This combined document contains Stop Lime Down:
Post hearing submissions,
Comments on Deadline 3 Submissions, and
Comments on Responses to ExQ1.

LIME DOWN SOLAR PROJECT

DEADLINE 4 COMMENTS STOP LIME DOWN

July 2026

Lime Down: Daily Generated HGV and LV Movements (Revised Calcs)

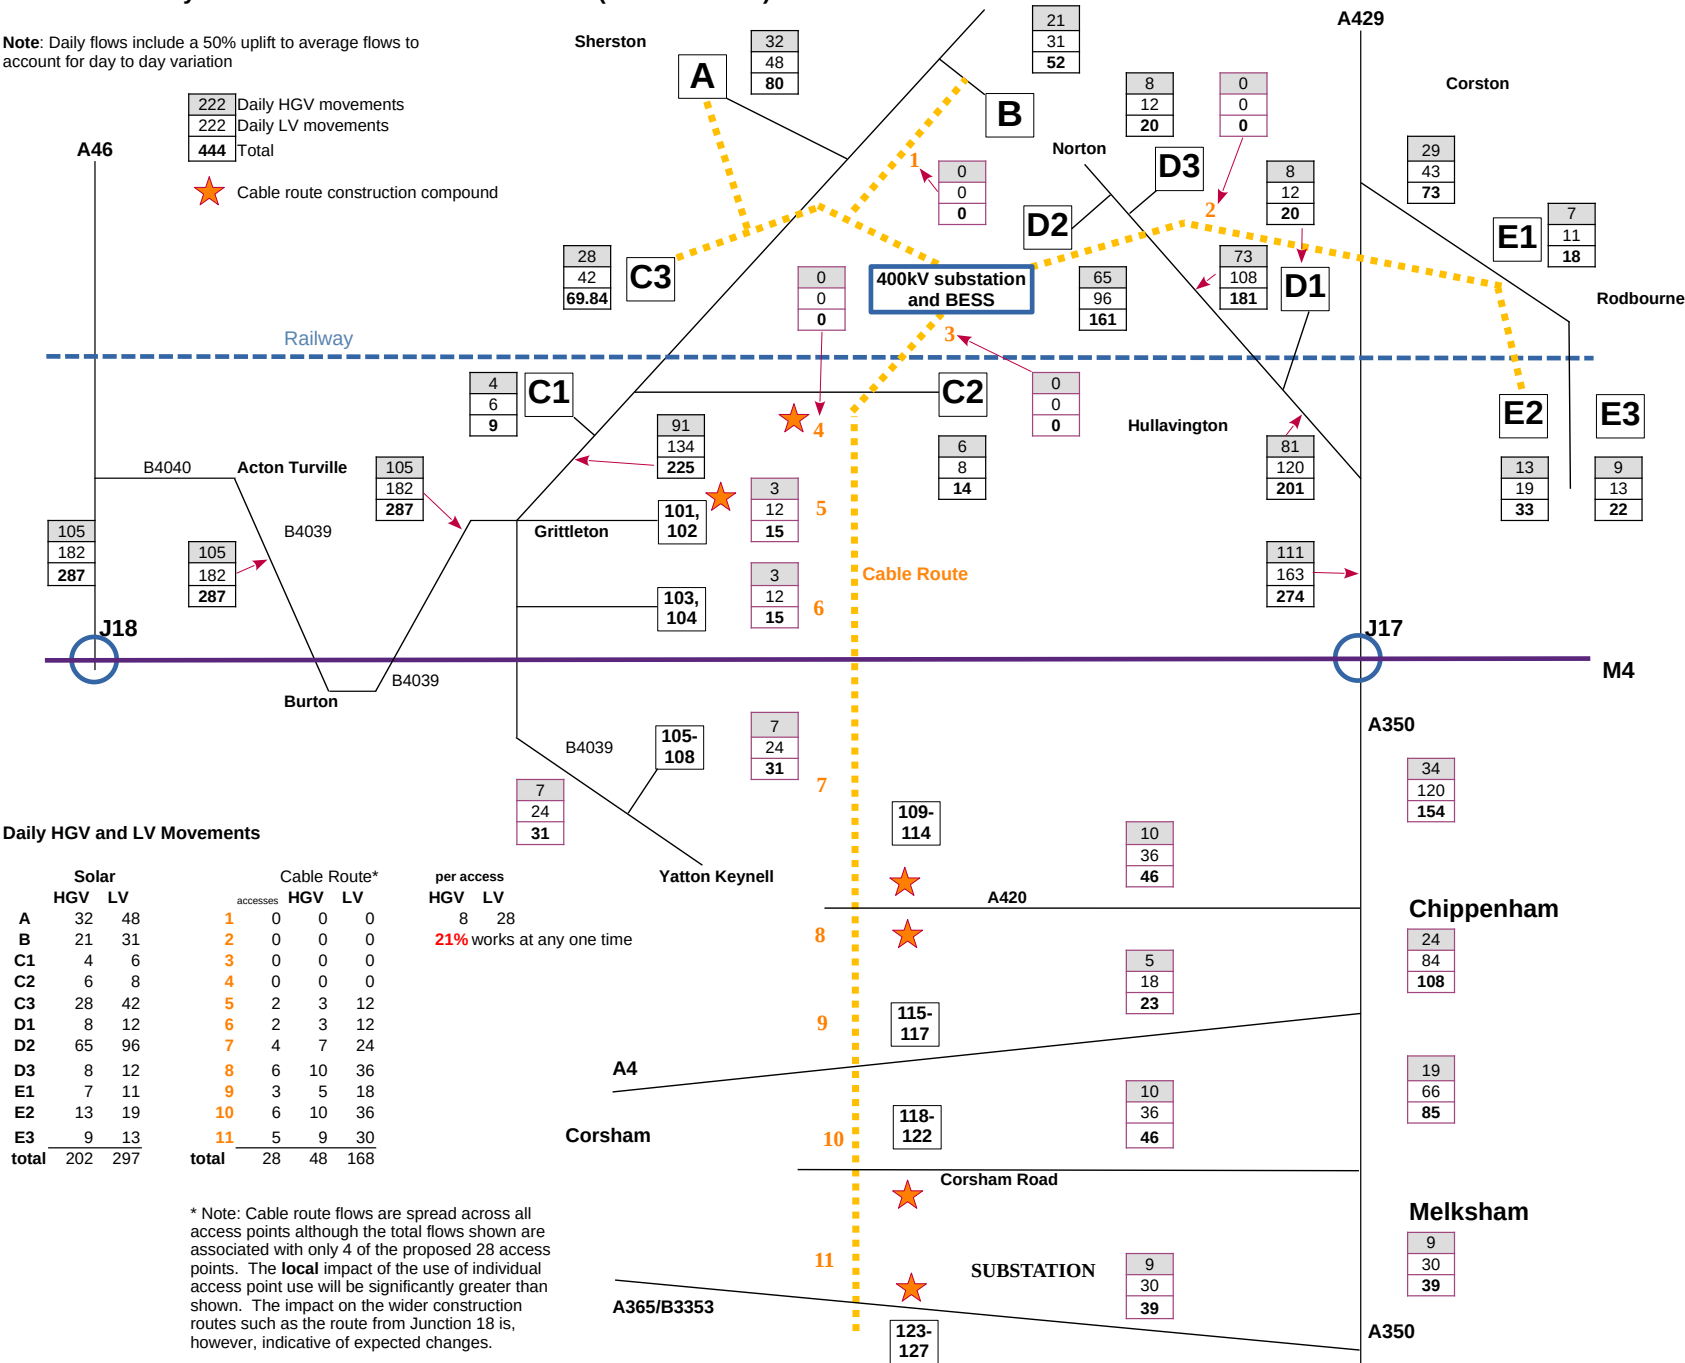
Number of accesses	28						
Days operating	90						
Total HGVs	10,080	4 per access per day					Total HGV movements including cable route
Total HGV movements	20,160					67,661	
Average HGV movements on a single day	32	4 accesses open at any one time					
With 50% uplift to represent day to day variation	48						
Total LGVs	10,080	4 per access per day					
Total HGV movements	20,160						
Average HGV movements on a single day	32	4 accesses open at any one time					
With 50% uplift to represent day to day variation	48						
cable route staff per access point	10						
car trips per day per access point	20	100.0% single occupancy car driver mode share					
total car trips	50,400						
Average total car trips on single	80						
With 50% uplift to represent day to day variation	120						
Total light vehicle movements	70,560						
Total daily LGVs and cars (50% uplift)	168

Lime Down: % Change in Daily HGV Movements (Revised Calcs)

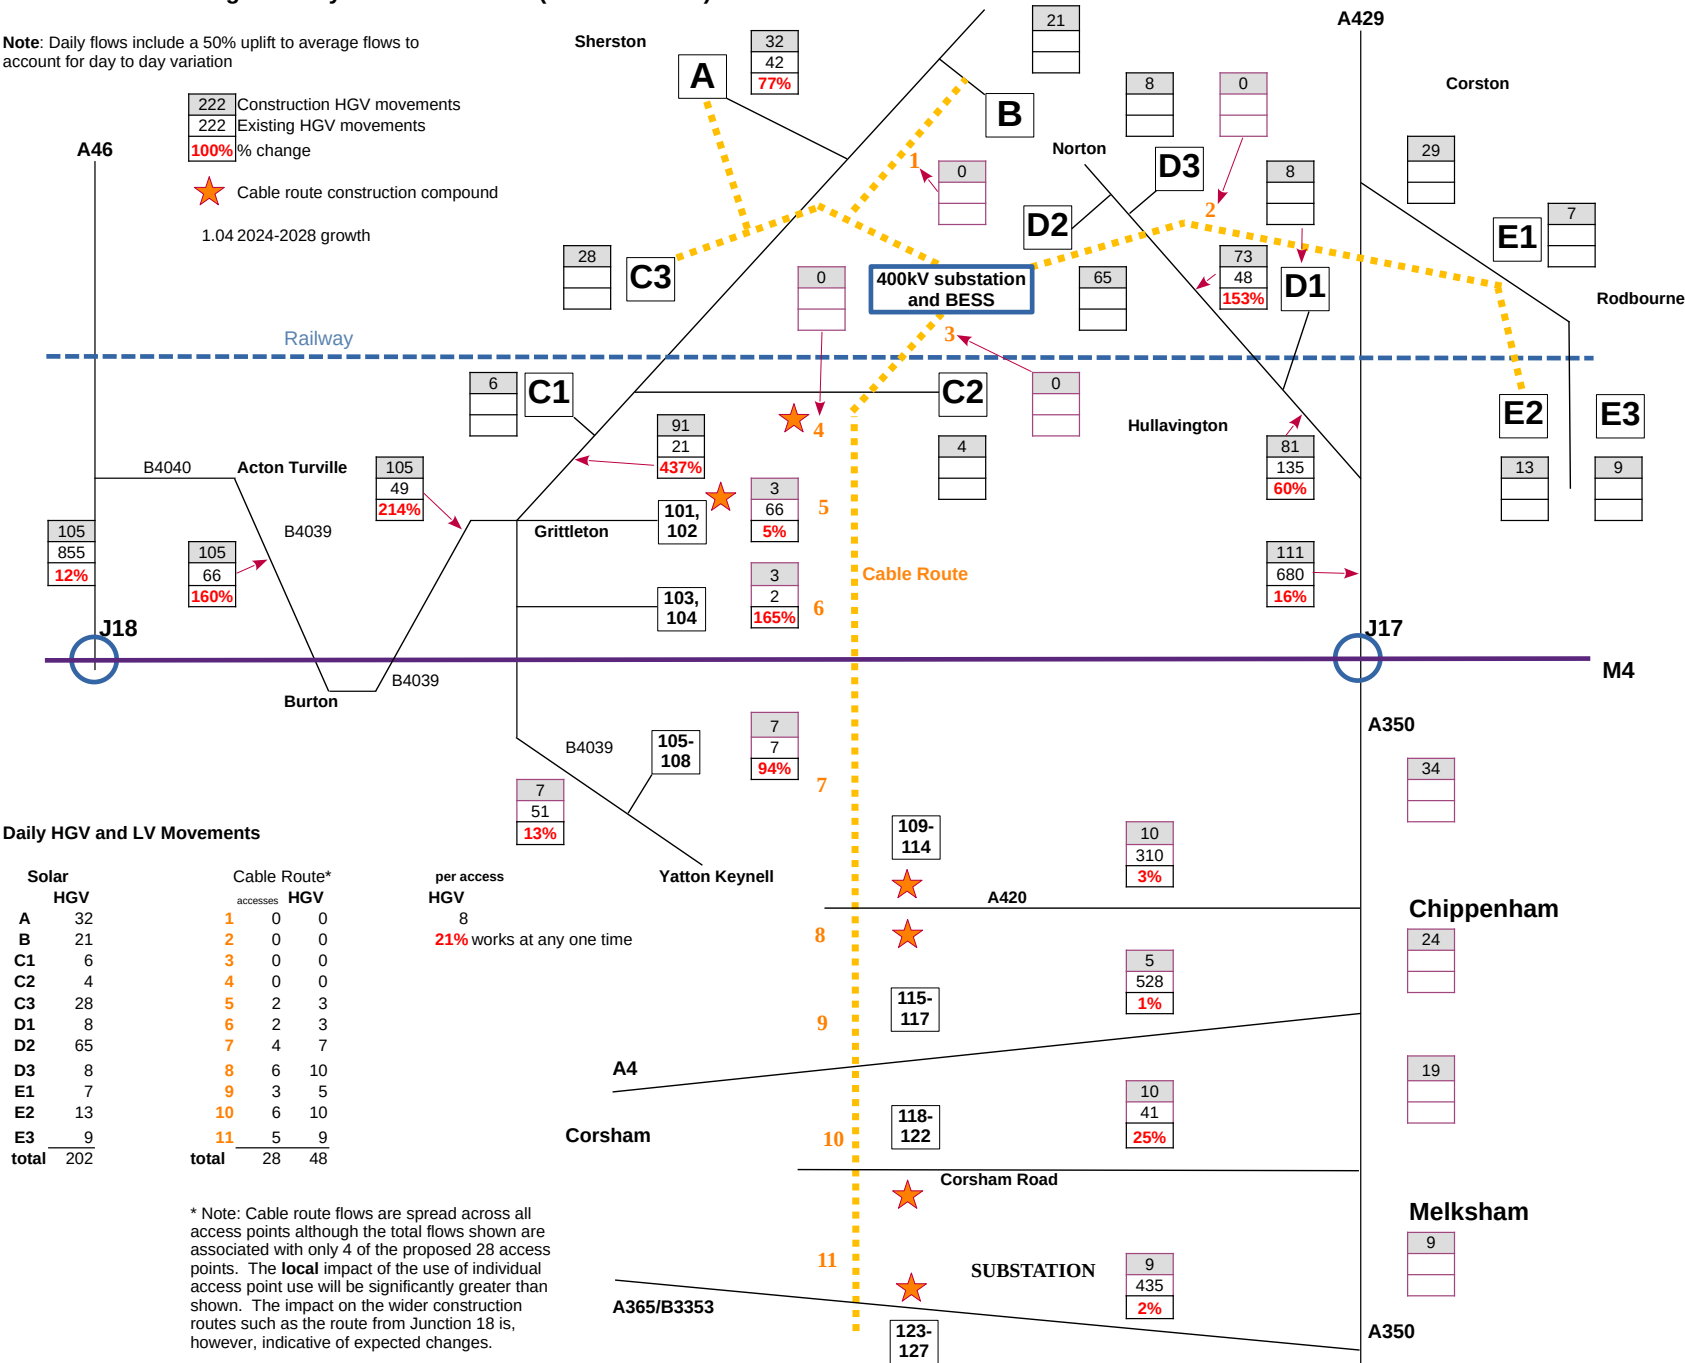
222 Construction HGV movements
222 Existing HGV movements
100% % change
